Preliminary Consultation
MONTGOMERY COUNTY HISTORIC PRESERVATION COMMISSION
STAFF REPORT

Address:	38 Philadelphia Avenue, Takoma Park	Meeting Date:	9/4/2024
Resource:	Contributing Resource Takoma Park Historic District	Report Date:	8/28/2024
Applicant:	DTP RE Fund 3, LLC (Richard Vitullo, Architect)	Public Notice:	8/21/2024
Review:	Preliminary Consultation	Staff:	Dan Bruechert
Proposal:	Construction of a new second-story and two-story rear addition with basement

STAFF RECOMMENDATION

Staff recommends the applicant make any revisions recommended by the HPC and return for a HAWP or a second preliminary consultation.

Figure 2: Front elevation of the subject property (left), and proposed elevation (right).

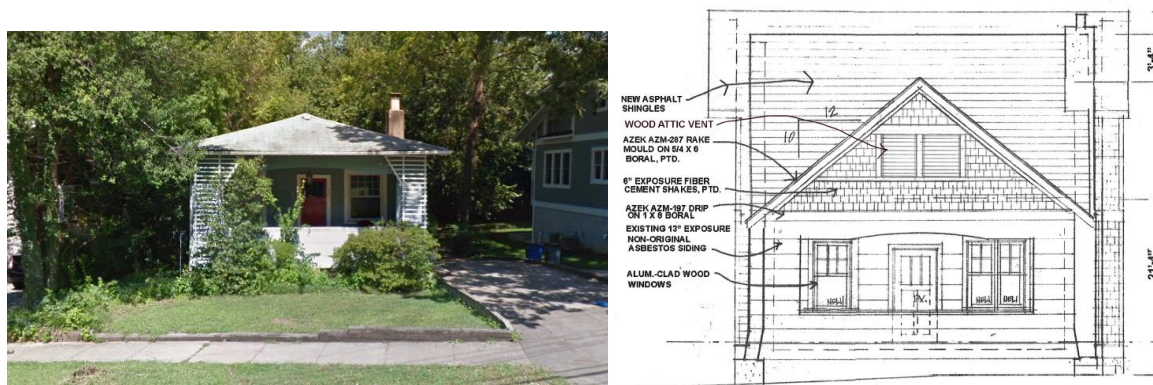
Staff finds that the proposed roof form proposed is commonly used in Craftsman architecture. *A Field Guide to American Houses* states, “cross-gabled examples make up about one-fourth of Craftsman houses.” An additional one-third of Craftsman houses are of what the *Field Guide* identifies as the front-gable subtype. However, Staff remains concerned that not enough of the existing character is retained by completely changing the roof line in this manner.

height of the houses in that stretch is 23' 7" (twenty-three feet, seven inches) and ranges from the subject property's low of 15' 4" (fifteen feet, four inches) to 31' (thirty-one feet tall) at 22 Philadelphia Ave. Staff finds the proposed roof height is not out of character with the surrounding streetscape, as the proposed roof height will be 21' 4" (twenty-one feet, four inches) at the front of the house, rising to 24' 8" (twenty-four feet, eight inches) approximately 20' (twenty feet) back from the front wall plane. The proposed height at the front is 1' (one foot) taller than the average height in the surrounding streetscape.

Proposals of this type clearly would not meet the Standards because of the dramatic change to the house massing, however, the administrative regulations for evaluating HAWPs state when there is a conflict between the Standards and any district-specific guidance, the district-specific guidance controls. So, Staff finds that the primary consideration is whether the proposal is consistent with the spirit and letter of the *Design Guidelines*, while still retaining some vestige of the house's character, per 24A-8(b)(2). Craftsman architecture is generally defined by a low-pitched gable or hipped roofs with wide, unenclosed eave overhangs with exposed roof rafters. Designs often incorporate exposed beams or braces under gables or porch eaves. Houses frequently have full or partial-width front porches supported with tapered columns. Staff recognizes that the subject property lacks ornamentation and really only expresses the low-pitched roof and exposed rafter tails that are associated with Craftsman architecture.

A few years ago, the HPC reviewed a proposal to modify the front porch at 7417 Baltimore Ave. In reviewing the proposal, the HPC revisited its 1995 approval of a second story.¹ In discussing the second

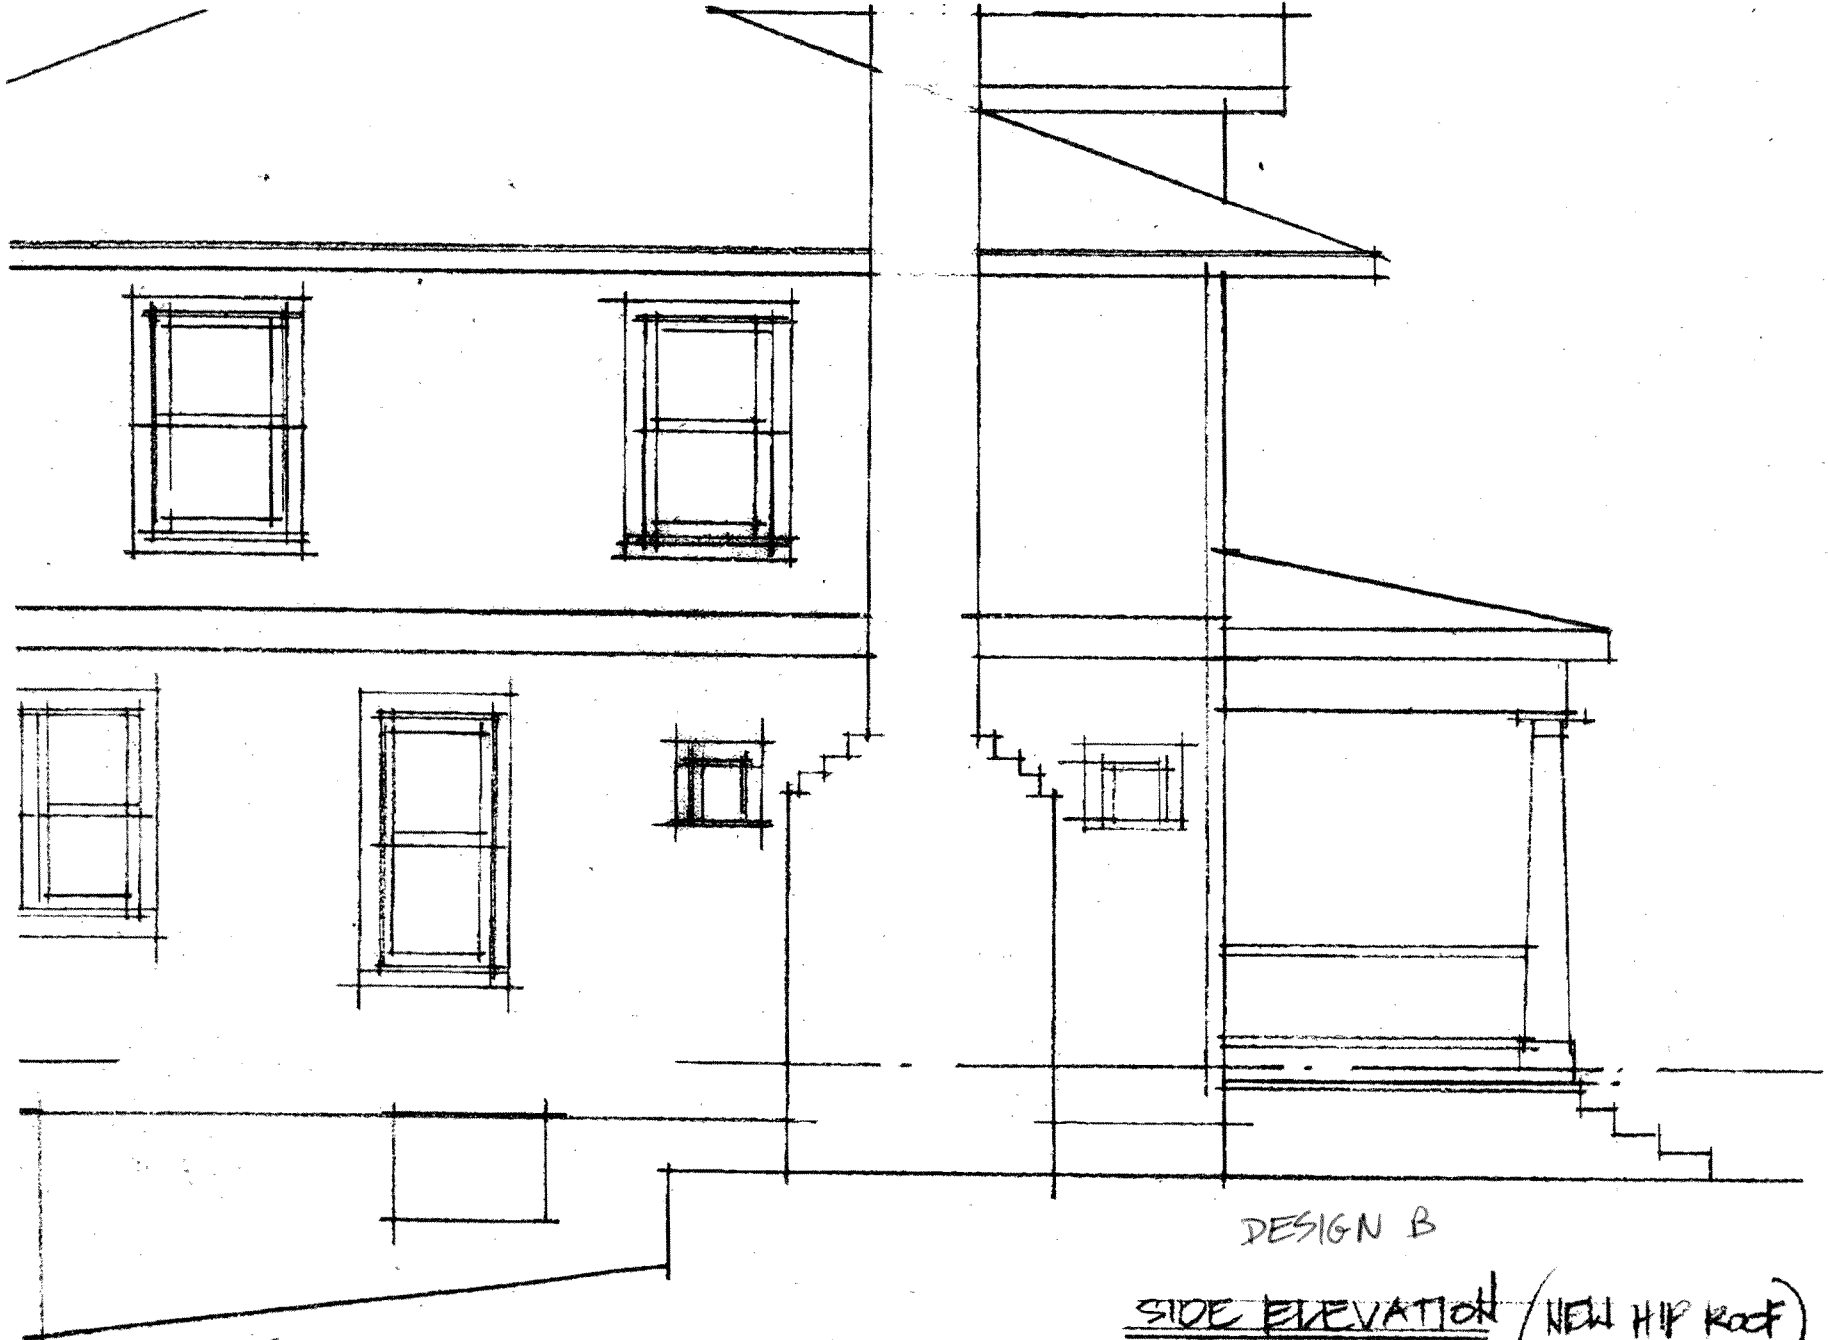
Here's the hip roof, placed on a full second floor. We could pull the roof height down some, but we'd have to change the pitch of the hip, as well as add dormers. Seems like it would be the same type of (major) change to the roof as my scheme.
